Improved Technical Specifications

LaSalle County Station

Volume 2:
Sections 3.1 and 3.2

ComEd

Figure 3.1.5-1

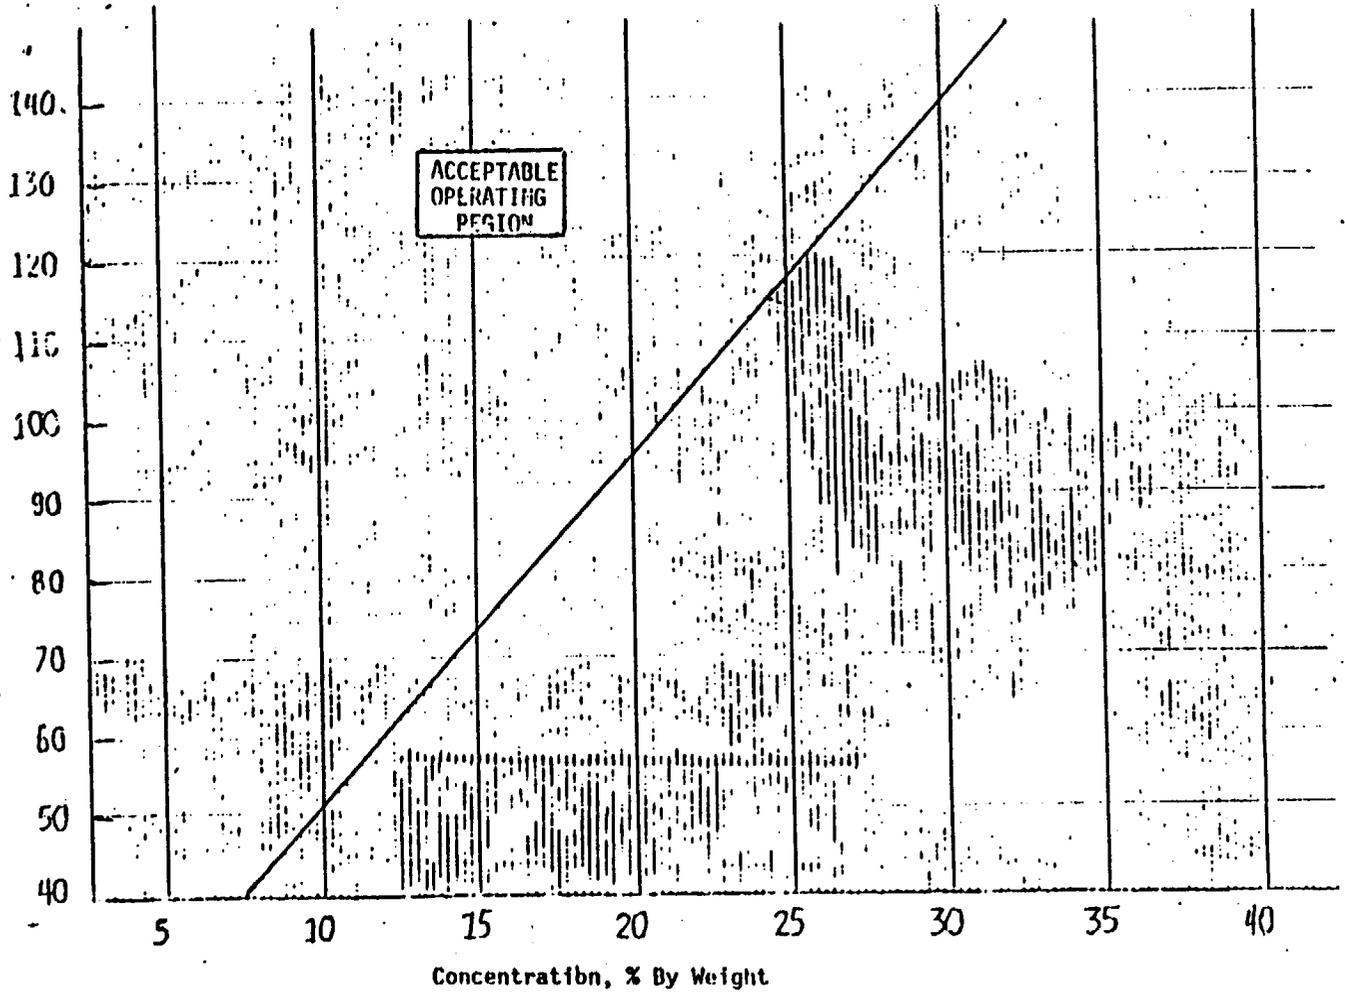
*This test shall also be performed anytime water or boron is added to the solution or when the solution temperature drops below the limit of Figure 3.1.5-1.

Figure 3.1.7-2

Figure 3.1.5-2

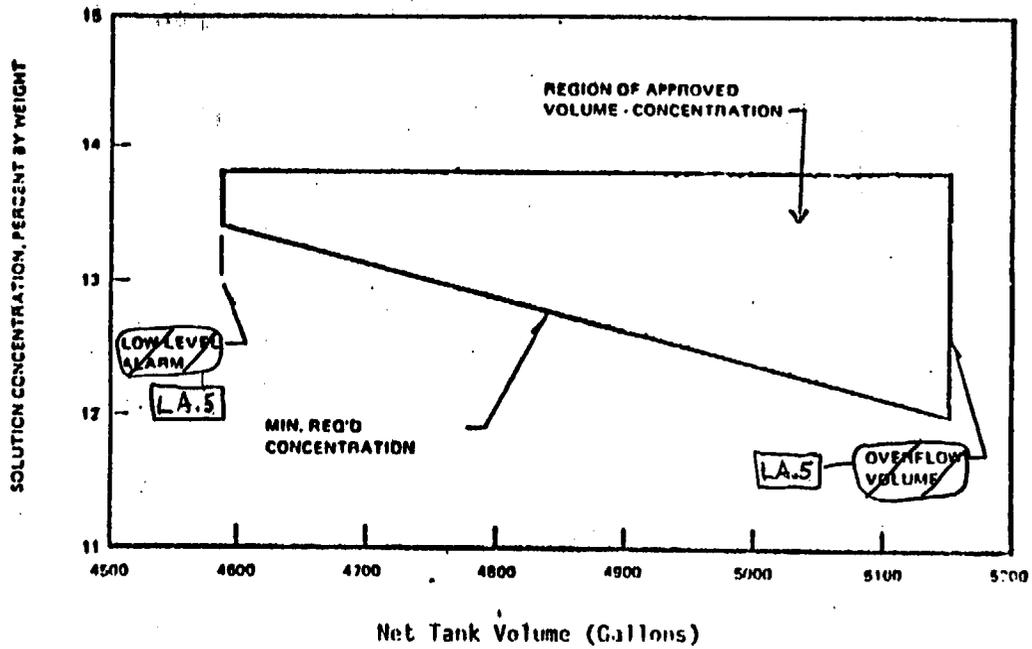
Figure 3.1.7-1

Figure 3.1.5-1

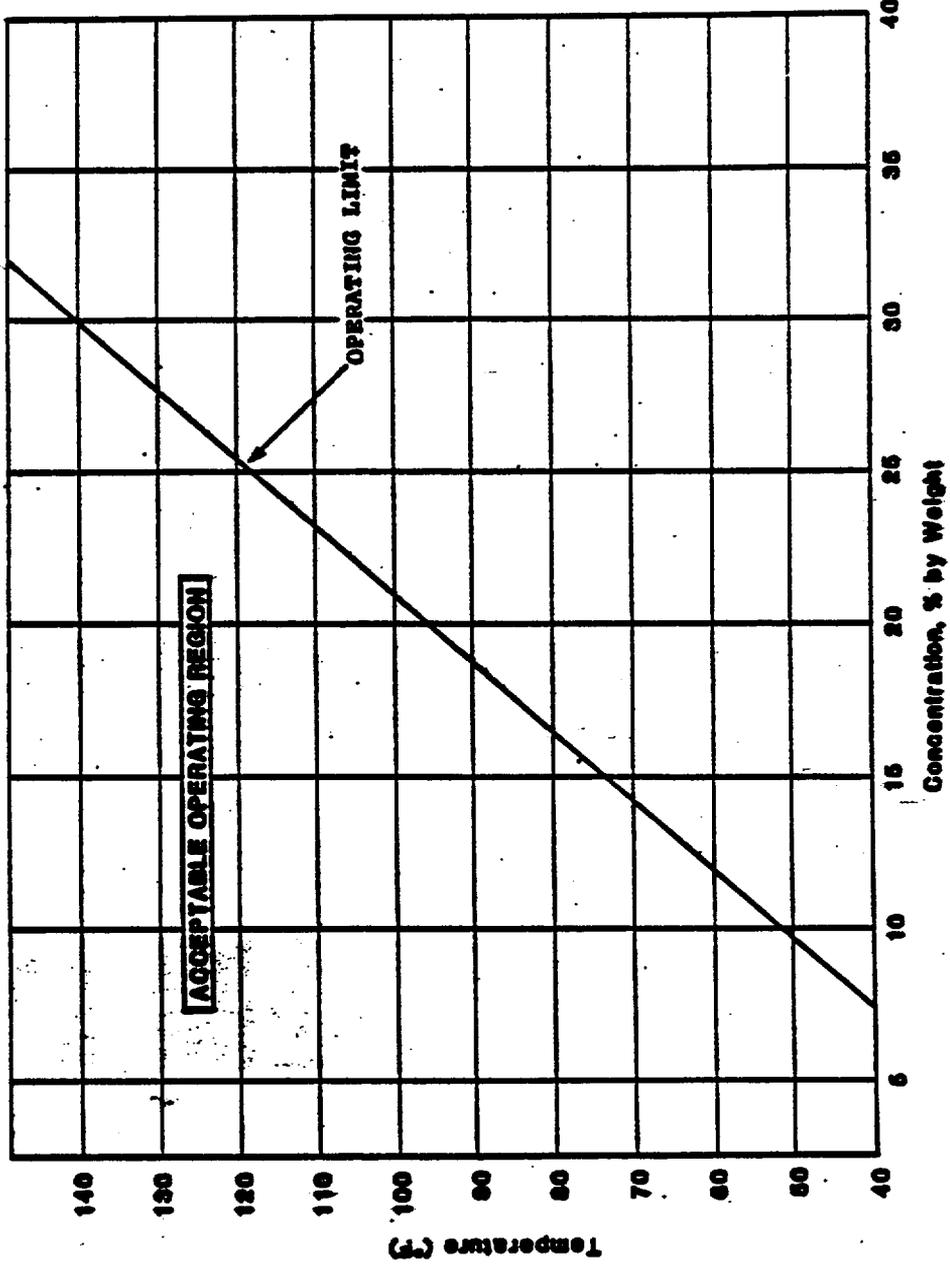
Figure 3.1.7-2

Figure 3.1.5-2

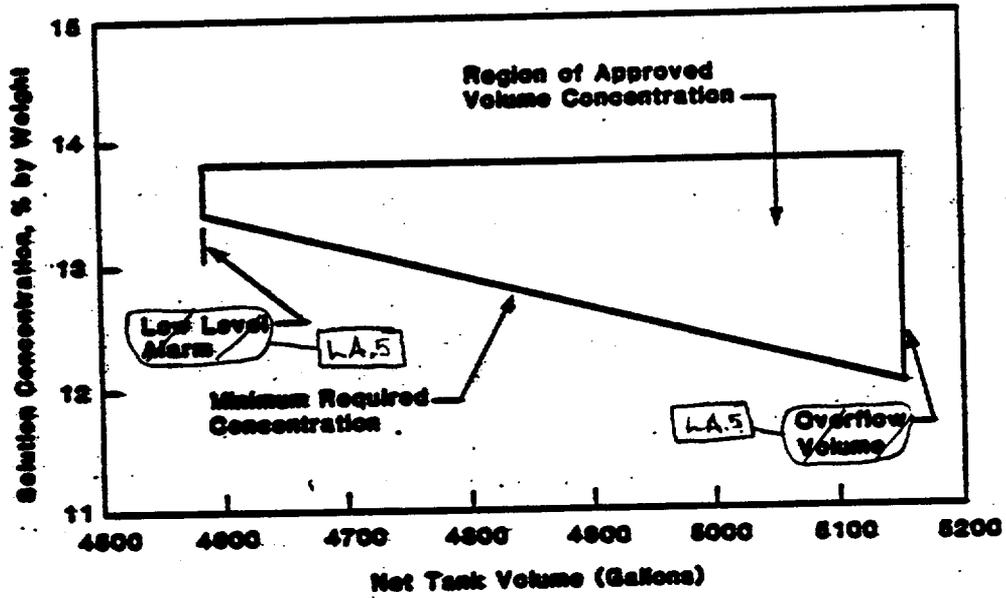
Figure 3.1.7-1
